Our Ref: 43126-006-01
Your Ref: MCU25/0091

**RESPONSE TO INFORMATION REQUEST
DEVELOPMENT APPLICATION FOR MATERIAL CHANGE OF USE
FOR CHILDCARE CENTRE (MCU25/0091)
2 TREELINE DRIVE, RASMUSSEN**

Rasmussen Early Learning Centre

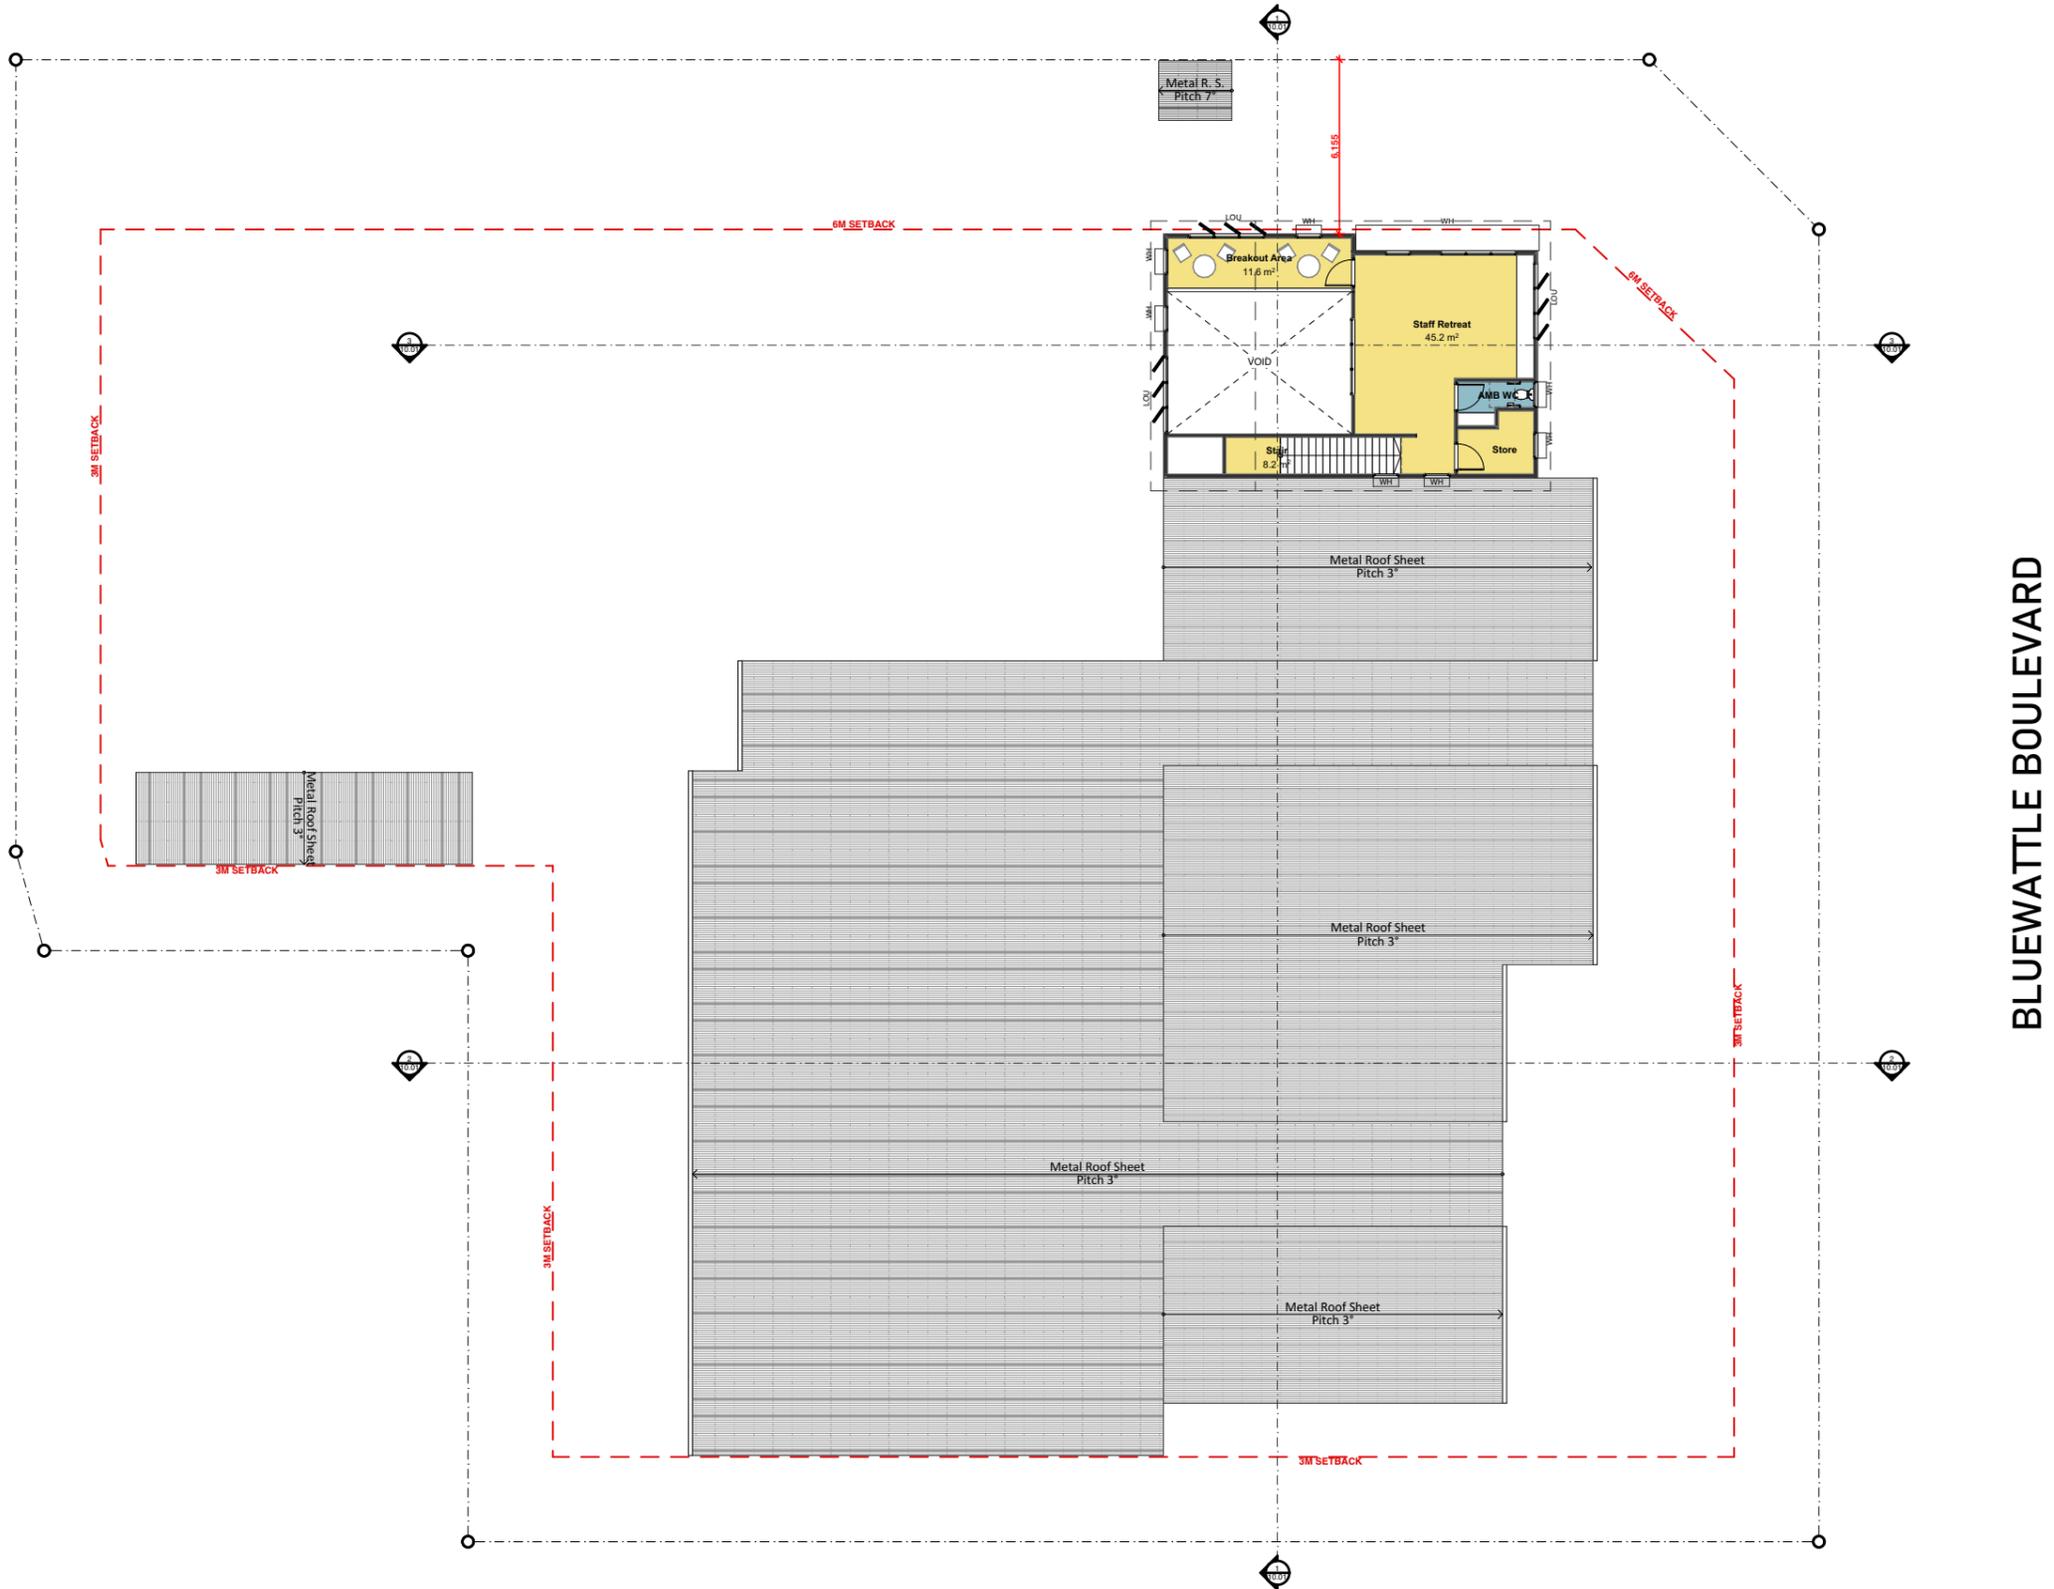
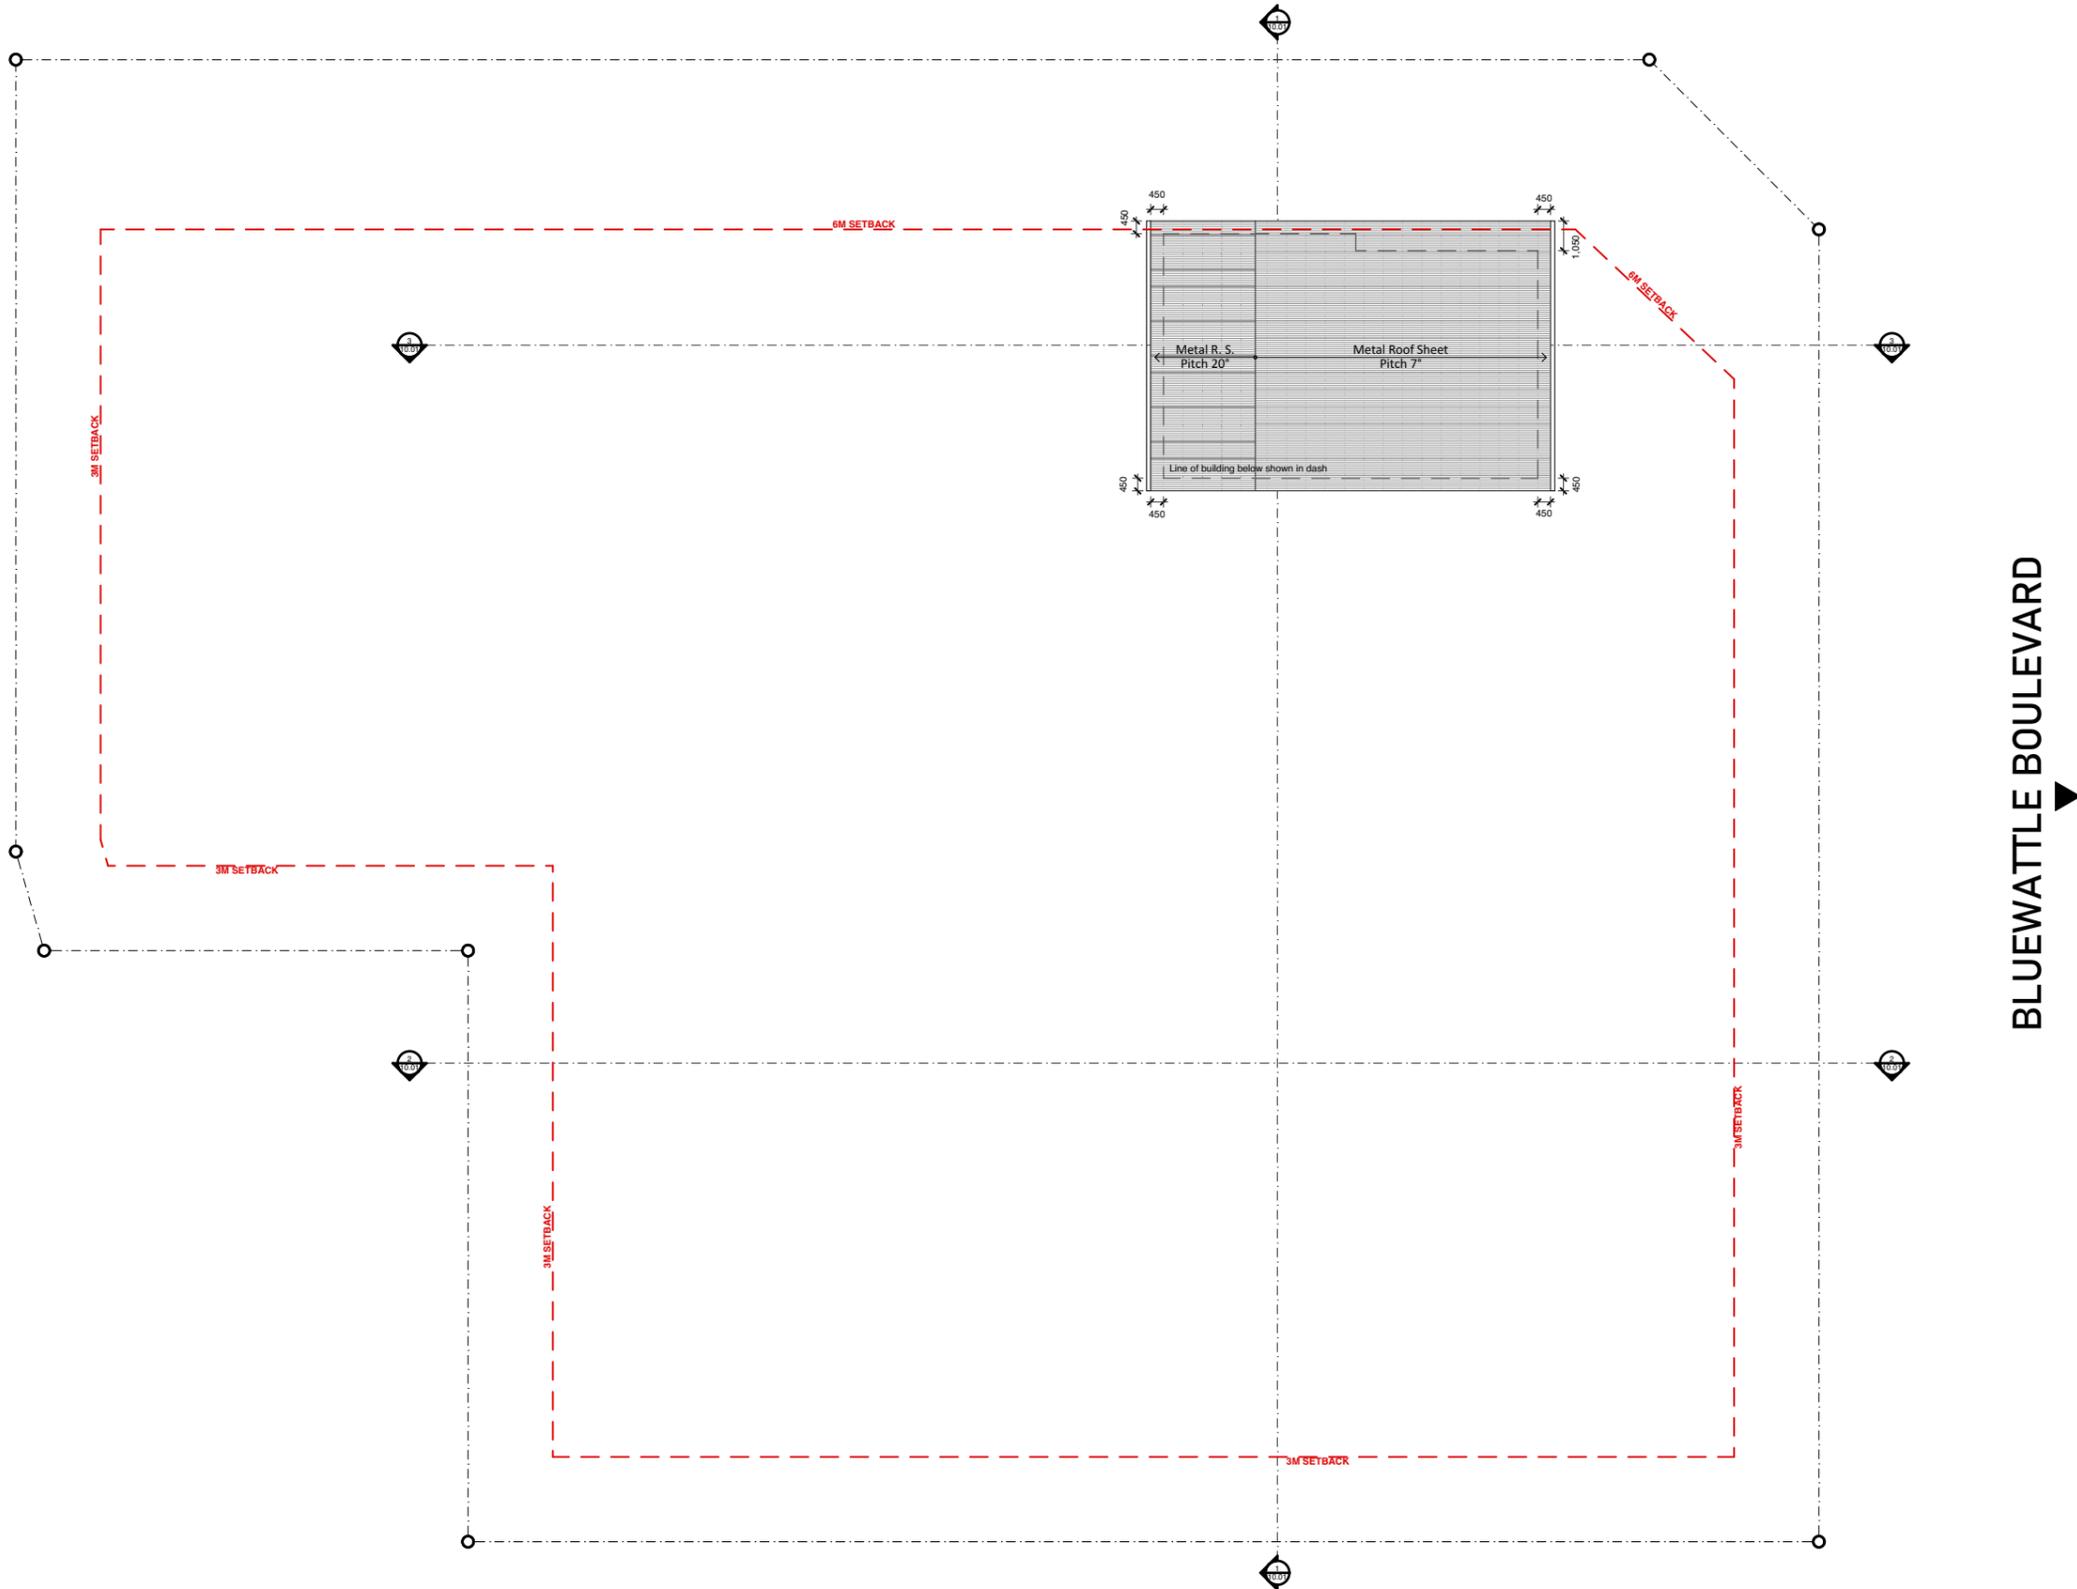
The applicant is requested to provide updated Plans and Landscape Concept Plans including detail of:

- *The location of any proposed fire booster cabinet;*
- *Additional articulation in built form and/or materiality of the 2 metre high rendered fence to the Bluewattle Boulevard / Saltbush Boulevard corner;*
- *Provision of gaps/breaks in garden beds along parking spaces 21 – 25 where they look to block access from car parking spaces to the path and building frontage.*

The development concepts and associated landscaping plans have been amended as per Council's request items. The updated concept and landscaping plans are included in **Appendices A** and **B**.

Figure 5-4: Modelled Noise Barriers

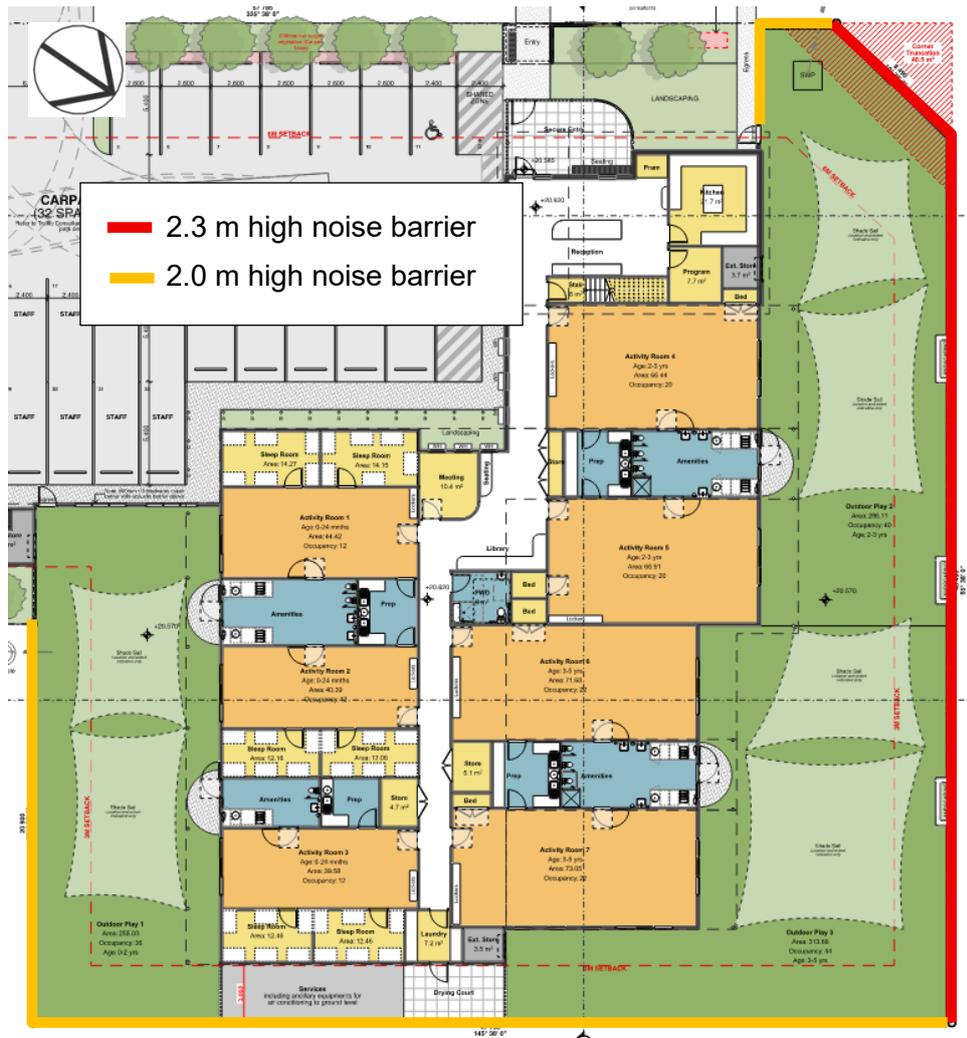
The solid fences (noise barriers) shown in **Figure 5-4** have been determined to be required to achieve compliance with Project noise limits and have been included in the noise model. The solid fences are to be constructed of materials achieving a minimum surface density of 12.5 kg/m². Suitable materials are expected to include, but are not limited to, 9mm fibrous cement sheeting, 75mm thick Hebel, 12 mm acrylic, or combination thereof.

The required noise barrier heights are shown in **Figure 5-4**, measured from the outdoor play area finished level of reduced level (RL) 20.62 m, and is so be comprised of solid continuous construction and free from gaps.

- To achieve compliance at first level, a 3.2 m high noise barrier is required in lieu of the proposed 2.3 m high noise barriers (refer to **Figure 5-4**).

- 2 Apply solid fences (acoustic barriers) as marked on site layout/plan **Figure 5-4**. The nominated solid fences are to be constructed of a material achieving a minimum surface density of 12.5 kg/m². Suitable materials are expected to include, but are not limited to, 9 mm fibrous cement sheeting, 75 mm thick Hebel, 12 mm acrylic, or combination thereof.
